# Access Compliance Report

## Public Rights-of-Way

### (Island Curb Cuts)

Intersection ID: 8113	Main Street: ORR_RD	Cross Street: GRIER_RD	Location: NW
ADA ID: A57242E8ABC3	Curb Cut Type: IslandRefuge3	Initial Pass/Fail: Fail	Overall Compliance: No
		Severity Score: 36.25

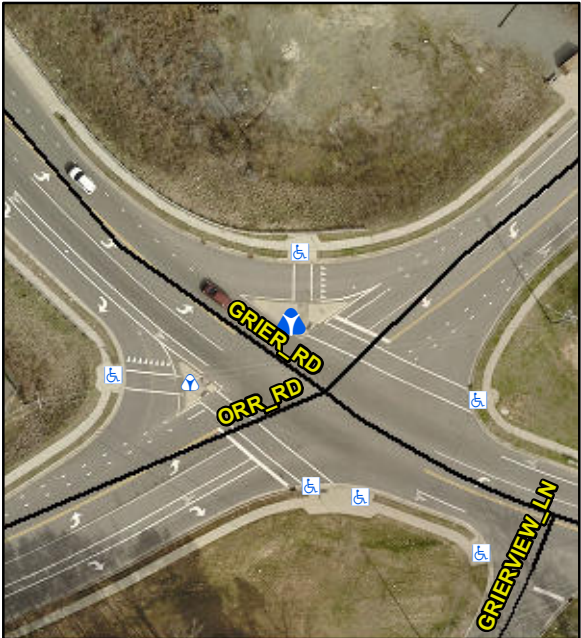
Codes/Mitigation Info/Possible Solution			Field Measurements/Component Compliance			
	Possible Solutions:		<b>Compliance</b>	<b>Description</b>	<b>Data</b>	
	<b>Remove &amp; Replace Entire Refuge.</b>		<b>Yes</b>	Refuge 1 Length (In)	<b>73.0</b>	<b>N/A</b>
			<b>No</b>	Refuge 1 Width (In)	<b>59.0</b>	<b>N/A</b>
			<b>Yes</b>	Refuge 1 Slope (%)	<b>1.7</b>	<b>N/A</b>
			<b>Yes</b>	Refuge 1 X Slope (%)	<b>0.0</b>	<b>N/A</b>
			<b>N/A</b>	Painted X Walk1?	<b>Yes</b>	<b>N/A</b>
			<b>N/A</b>	X Walk 1 Direction	<b>To SE</b>	<b>N/A</b>
			<b>N/A</b>	X Walk 1 Width (In)	<b>117.0</b>	<b>N/A</b>
			<b>N/A</b>	Road 1 Slope (%)	<b>2.2</b>	<b>N/A</b>
			<b>N/A</b>	Road 1 X Slope (%)	<b>1.4</b>	<b>N/A</b>
<p>Surveyor Notes:</p> <p><b>N/A</b></p>			<b>Yes</b>	Refuge 2 Length (In)	<b>52.0</b>	<b>N/A</b>
			<b>Yes</b>	Refuge 2 Width (In)	<b>61.5</b>	<b>N/A</b>
			<b>Yes</b>	Refuge 2 Slope (%)	<b>2.7</b>	<b>N/A</b>
			<b>Yes</b>	Refuge 2 X Slope (%)	<b>0.1</b>	<b>N/A</b>

<b>N/A</b>	Painted X Walk2?	<b>No</b>	<b>N/A</b>
			<b>N/A</b>	X Walk 2 Direction	<b>To SW</b>	<b>N/A</b>
			<b>N/A</b>	X Walk 2 Width (In)	<b>N/A</b>	<b>N/A</b>
			<b>N/A</b>	Road 2 Slope (%)	<b>0.5</b>	<b>N/A</b>
			<b>N/A</b>	Road 2 X Slope (%)	<b>2.2</b>	<b>N/A</b>
			<b>Yes</b>	Refuge 3 Length (in)	<b>86.0</b>	<b>N/A</b>
<p>PROW/ADA:</p> <p><b>N/A</b></p>			<b>Yes</b>	Refuge 3 Width (in)	<b>60.0</b>	<b>N/A</b>
			<b>Yes</b>	Refuge 3 Slope (%)	<b>0.4</b>	<b>N/A</b>
			<b>Yes</b>	Refuge 3 XSlope (%)	<b>0.9</b>	<b>N/A</b>
			<b>N/A</b>	Painted X Walk3?	<b>Yes</b>	<b>N/A</b>
			<b>N/A</b>	X Walk 3 Direction	<b>To N</b>	<b>N/A</b>
			<b>N/A</b>	X Walk 3 Width (in)	<b>103.5</b>	<b>N/A</b>
			<b>N/A</b>	Road 3 Slope (%)	<b>1.9</b>	<b>N/A</b>
			<b>N/A</b>	Road 3 XSlope (%)	<b>2.8</b>	<b>N/A</b>
			<b>Yes</b>	Any Obstructions?	<b>N/A</b>	<b>N/A</b>
			<b>N/A</b>	Obstruction Type	<b>N/A</b>	<b>N/A</b>
<p>Total Cost:</p> <p><b>\$ 3000.00</b></p>			<b>N/A</b>	Storm Grate/Utility Hazard?	<b>N/A</b>	<b>N/A</b>
